# PERMIT

## SEWAGE DISPOSAL SYSTEM

SUBDIVISION The Heritage LOT 16 ROAD 14108 Bison Court

REPAIR - PURPOSE - In support of building permit application #: B00112635. For an addition.  
Call for an inspection when the ground is opened so a sanitarian can recommend repairs. 7-1-98.

SITE PLAN  
 LOT 16 "THE HERITAGE"

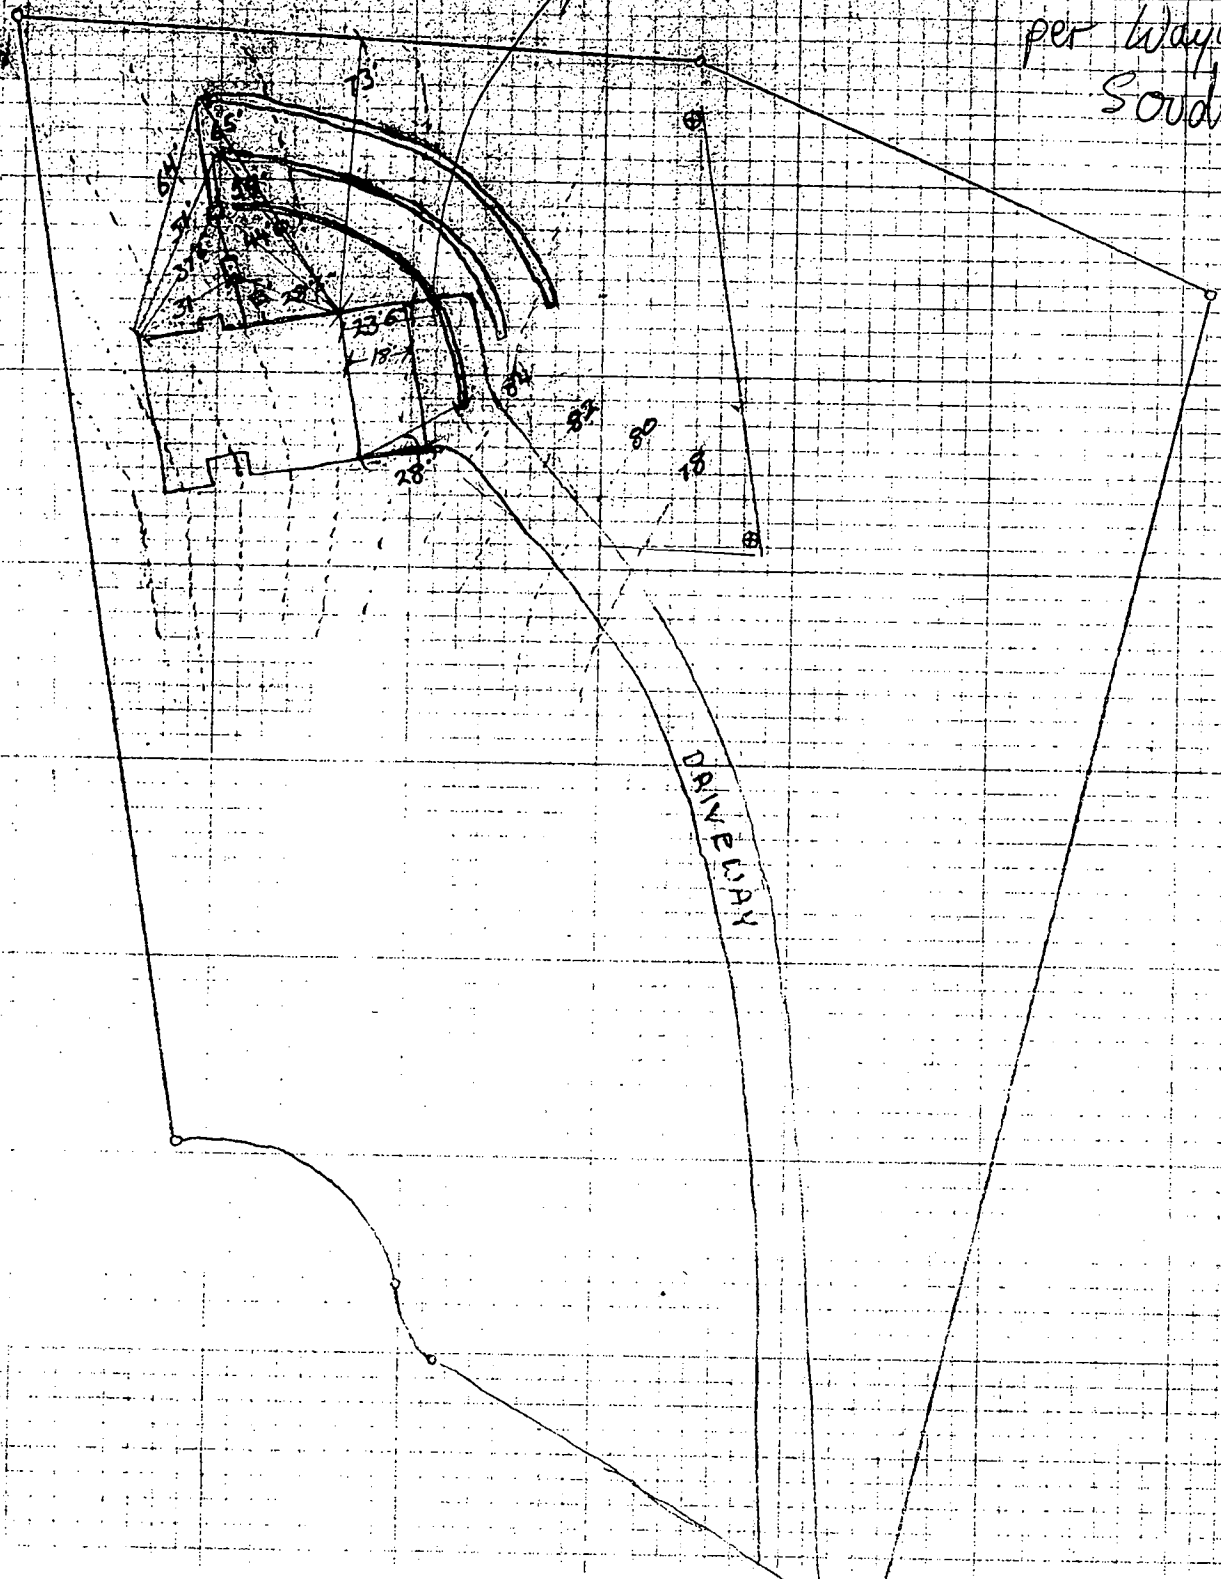
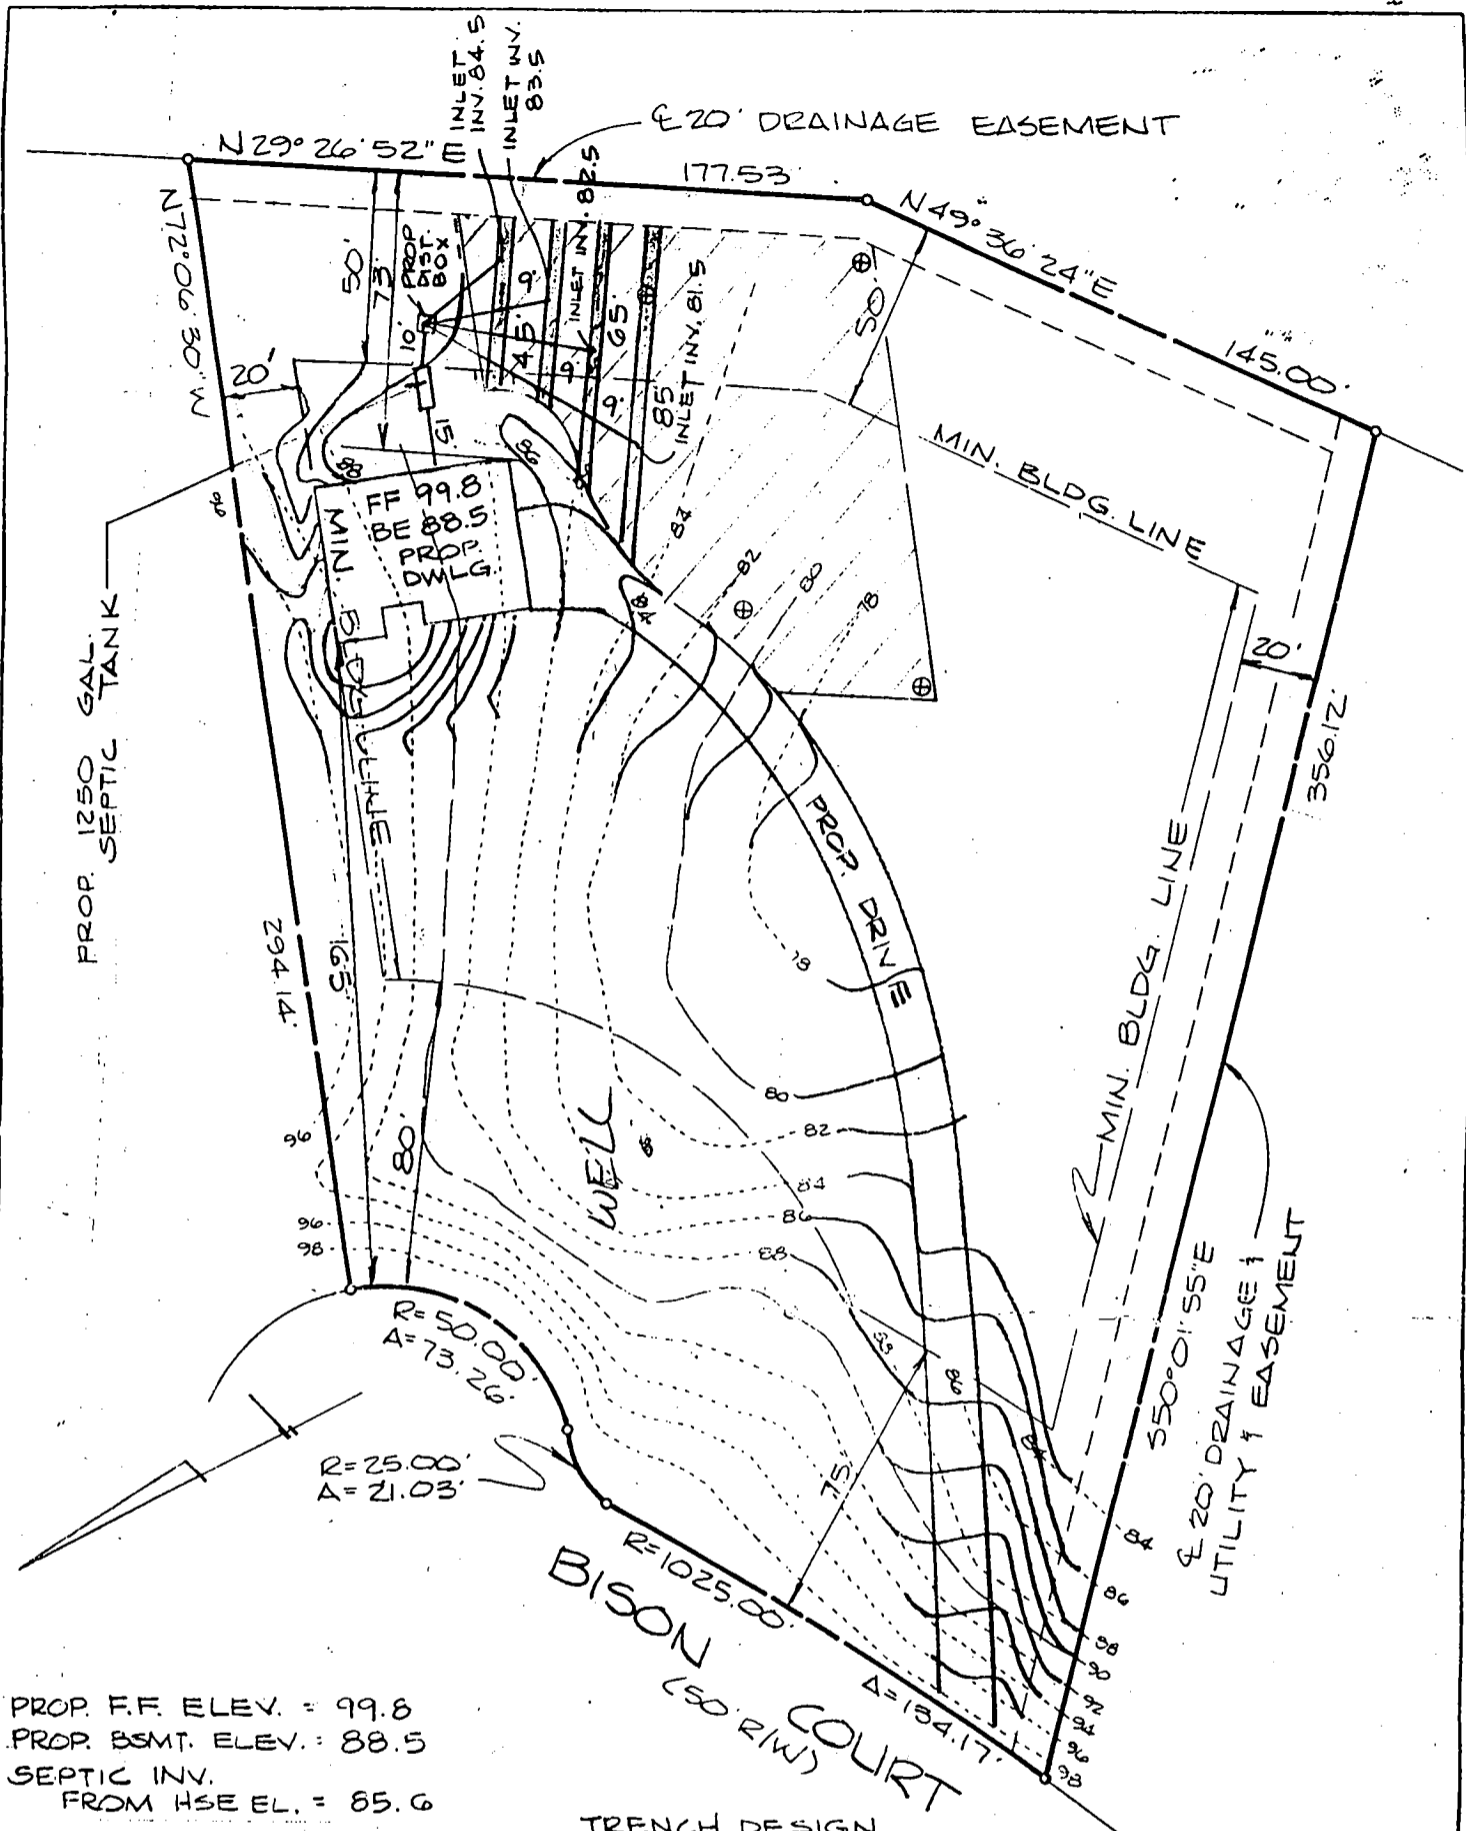
Addition will be 5' away from highest trench  
elevation from pipe to top of floor 7'

7' elev. diff betw. the top of the dist. pipe which is a walk out at grade.

per Wayne  
Souders

DECISION AFTER FURTHER REVIEW (MR) 7/13/98 ± CONTRACTOR'S PROPOSAL OK AFTER DISCUSSION w/CW (MR)
